Submissions and Amendment Report

**Infill Affordable Housing
138 Maroubra Road, Maroubra
SSD-81426710**

**19 May 2026
240128**

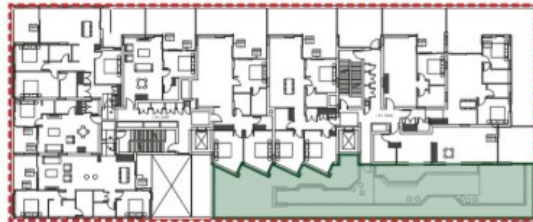
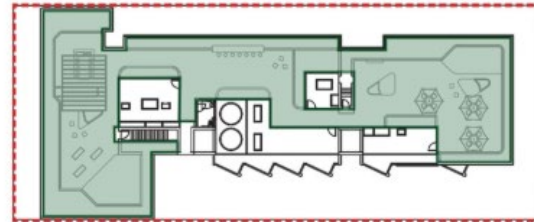
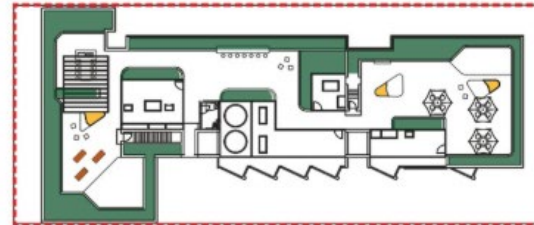
18	Revise the landscape area calculation plan to provide separate calculations of landscaped area and communal open space areas.	• Refer to the amended Landscape Drawings which shows the total landscaped area coverage and the Architectural Drawings which measures compliant communal open space.

Item	Issue / Comment	Applicant Response																
		LEVEL 2  LEGEND - Site Boundary - Landscape Area Coverage <table><tr><th>Apartment Design Guide (ADG)</th><th>DA</th></tr><tr><td>Site area</td><td>1,517.4 sqm</td></tr><tr><td>Communal Open Space</td><td>225 sqm</td></tr><tr><td>Total provided</td><td>15%</td></tr></table> ROOF TOP  LEGEND - Site Boundary - Landscape Area Coverage <table><tr><th>Apartment Design Guide (ADG)</th><th>DA</th></tr><tr><td>Site area</td><td>1,517.4 sqm</td></tr><tr><td>Communal Open Space</td><td>644 sqm</td></tr><tr><td>Total provided</td><td>42.5%</td></tr></table> Figure 1: Landscape area coverage Source: Place Design Group LEVEL 2  LEGEND - Site Boundary 1200mm planters 500mm planters ROOF TOP  LEGEND - Site Boundary 1200mm planters 1000mm modular seating planters 750mm planter boxes Figure 2: Planting areas Source: Place Design Group	Apartment Design Guide (ADG)	DA	Site area	1,517.4 sqm	Communal Open Space	225 sqm	Total provided	15%	Apartment Design Guide (ADG)	DA	Site area	1,517.4 sqm	Communal Open Space	644 sqm	Total provided	42.5%

Apartment Design Guide (ADG)	DA																	
Site area	1,517.4 sqm																	
Communal Open Space	225 sqm																	
Total provided	15%																	
Apartment Design Guide (ADG)	DA																	
Site area	1,517.4 sqm																	
Communal Open Space	644 sqm																	
Total provided	42.5%																	
19	Revise the comparison shadow plan (DA8.321) as it does not appear to depict the proposal accurately.	- Shadow plan DA8.321 compares the proposed development with a 6-storey ‘DCP envelope’ as well as an 8-storey ‘DCP + 30% Affordable Housing envelope’. The study finds that at mid-winter between 12pm and 2pm; – the DCP envelope would overshadow 4 balconies

Figure 3: Inequitable share of building separations with the Police Station (Source: Applicant)

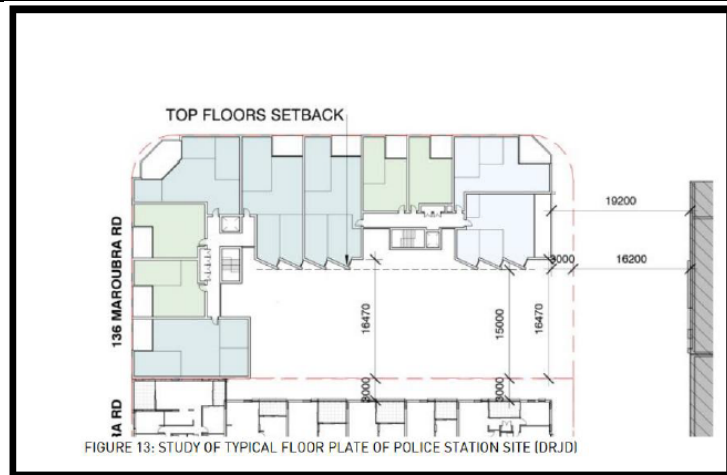
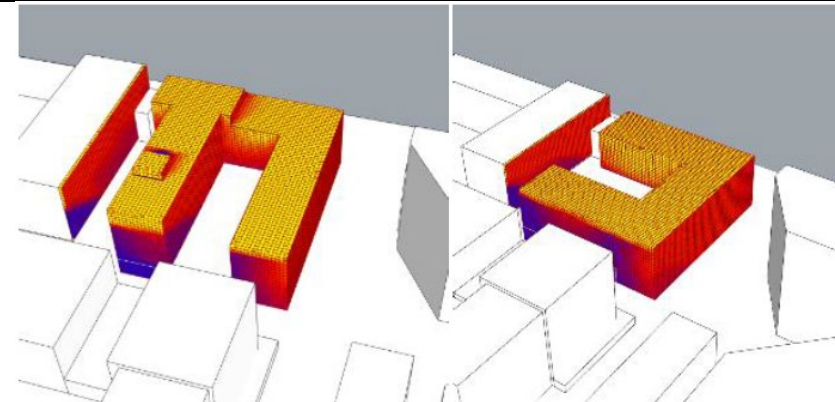
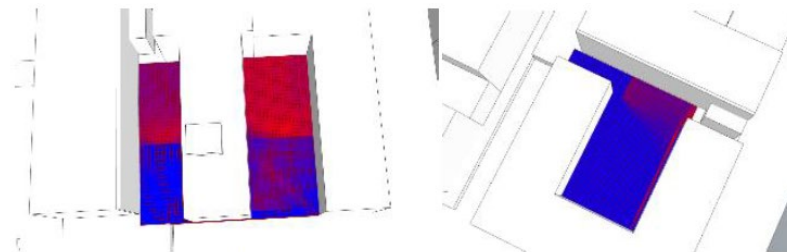
Building Envelope		
8	1. Building separation The proposal does not comply with the numerical requirements of the building separation in the Apartment Design Guide. The following areas of concerns are noted in the review of the plans: • On the southern frontage there is a nil side setback to the east and west from level 1 to level 8. These are blank walls. • The terraces on the 2nd floor also provides a nil side setback to the west and a nil rear setback to the north. The communal open space has a nil side setback to the east. • From levels 3 – 8, there is a 3m side setback to the west. • The rear side setback is 3m and the eastern side setback to the east is 6.45m. These separations and setbacks are not supported. Concern is raised for the proposed western side setback. It is not considered reasonable for the applicant to assume the redevelopment of the neighbouring property, without any formal block plan. The share of setback distances are not equitable, noting that the development site provides 3m, whereas the adjoining site is being expected to provide a minimum of 15m.	• The proposed development provides adequate building separation on a constrained site that maintains privacy to existing neighbours and that facilitates future feasible development of the NSW Police Site. • The proposed building separation is consistent with the objectives of Part 3F Visual Privacy of the ADG, being: – Adequate building separation distances are <u>shared equitably</u> between neighbouring sites, <u>to achieve reasonable levels of external and internal visual privacy</u>. – Site and building design elements (such as louvres and screening) increase privacy without compromising access to light and air and balance outlook and views from habitable rooms and private space. • The design guidance in Part 3F-1 notes that “new development should be located and oriented to <u>maximise visual privacy between buildings on site and for neighbouring buildings</u>.” • The strict adherence to the DCP when the site cannot be developed in concert with the adjoining site to deliver an integrated block form is overly burdensome and a merit based approach to the site should be taken. • A solar heat map comparison of the DCP and proposed envelopes including a future police site development were prepared in the joint expert planning and urban design report during the previous LEC matter (p 39). The comparison demonstrated that the proposed envelope achieved better solar access than the DCP envelope and was consistent with the ADG objective to maximise solar access-

- The proposed setback to the NSW Police Site to the west is a reasonable response to the constraints of the site and will allow the Police site – should it ever be redeveloped – to deliver zero-boundary setbacks to its three street frontages to maximise GFA.
- Council's DCP (which does not apply to the SSD) seeks an inequitable 'share' of GFA across the development site and the police site as shown in the below figure, and as outlined in the Design Report prepared by DJRD and the EIS.
- The proposed side setbacks meet ADG habitable to non-habitable building separation requirements and utilises 'pop-out' windows as per the ADG 'Hutchison' case-study.
- Overall, the proposed development provides adequate building separation in the specific circumstances of the development, and achieves appropriate privacy and solar access for existing and future development per the objectives of the ADG.

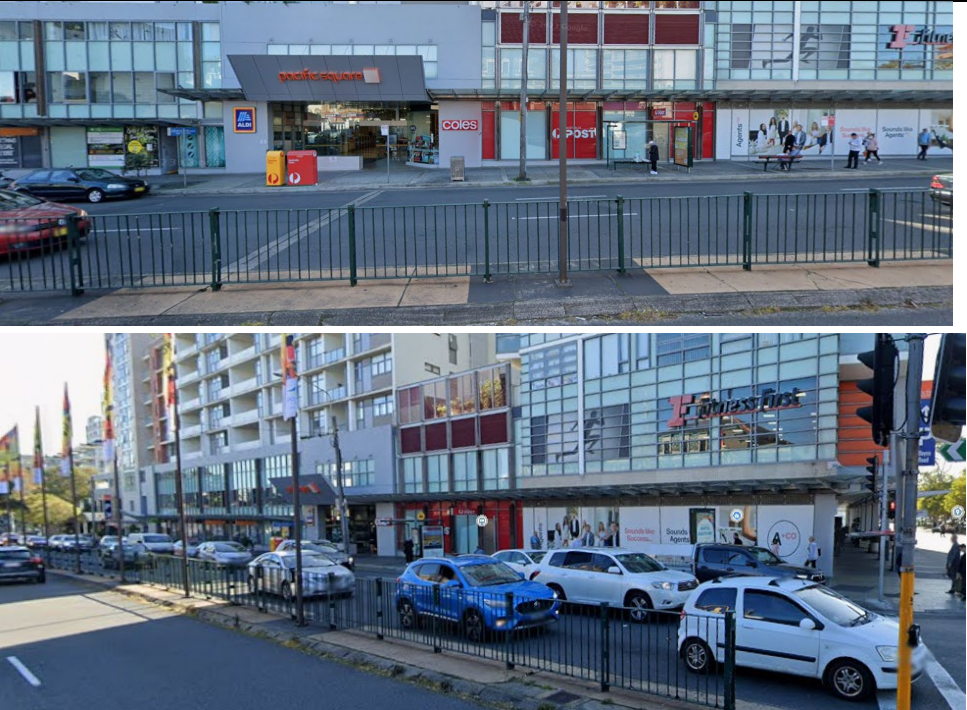
4. Vulnerability of future overshadowing from the redevelopment of the Police station – inconsistent with Maroubra Junction DCP. As shown in the Eye of the Sun Diagrams much of the development will not receive sunlight in the case of a similar scale redevelopment of the Police Station to the west and that sunlight access would be predominantly lost from 1:30pm to 3pm.	• DCP Envelope Analysis was prepared by DJRD with the EIS (Appendix E, DA0.150). The analysis demonstrates that in the event that the Police Station site is developed to a commensurate height, depth and GFA to the proposed development, that both developments achieve minimum solar requirements per the ADG. • The analysis demonstrates that the proposed development is not overshadowed by a future police station site between at least 9am and 1pm on the 21 June.

Item	Issue/ Comment	Proponent Response
		 Figure 6: Sun eye diagram and comparison to DCP envelope Source: DJRD
Maroubra Junction Development Control Plan		
11	Randwick Council's Draft DCP states that the objectives of Block 6 are to: 1. Reinforce Anzac Parade as the main street 2. Reinforce Maroubra Road as the cross street 3. Reinforce the "Junction" of Maroubra Road and Anzac Pde as the main focus of the Maroubra Junction Centre. 4. Encourage a mix of commercial/retail uses within the retail core 5. Provision of an open space in the middle of the centre away from the traffic noise and surrounded by shopping activity providing the focus for the centre 6. Provide a transition in scale from the centre along Boyce Rd, Maroubra Rd and Glanfield St to the lower scale residential buildings on the periphery. 7. Maintain the amenity of the residential buildings by providing a green buffer between the busy commercial/retail activities on Anzac Parade and adjacent low scale residential use. The building envelope plan anticipates a maximum of 6 stories along Maroubra Road. It also states that between Anzac Parade and Bruce Bennetts Place, there should be two levels of retail/commercial with residential above that is not provided in the subject scheme.	• The DCP does not apply to the SSD. • The anticipated building envelope must consider all of the planning controls that apply to the site including Chapter 2 of the Housing SEPP, which permits additional height in exchange for the provision of infill affordable housing. • The proposed development is consistent with the built form as anticipated under Chapter 2 of the Housing SEPP. • One level of retail uses are proposed to the ground floor. This approach is considered appropriate for a number of reasons, not least that the proposal has sought to reduce the number of basement levels to minimise excavation depth. The DCP control does not apply in any case.

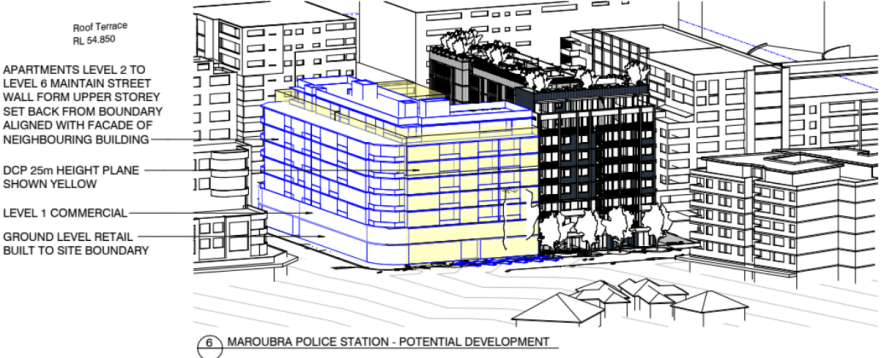
75	Loss of Privacy and Overshadowing	
	Views from and sunlight to Pacific Square, particularly upper level residences on the western and south-western side, are directly or materially impacted by the proposed development, particularly on the upper level	A View and Visual Impact Assessment (VVIA) was prepared with the EIS (Appendix P). The VVIA demonstrated that some surrounding residential dwellings will experience low or moderate view loss, however these views are inherently susceptible to change as they are obtained across common boundaries within a dense urban centre, and the proposed development is compliant with the maximum building height permitted at the site.
	Units on lower levels of the Botanica Building will directly face the new building with minimal separation, resulting privacy and overshadowing impacts.	The proposed development provides ADG building separation to the Botanic Building across Picadilly Lane, and is an acceptable approach given the infill nature of the development within a dense urban environment.
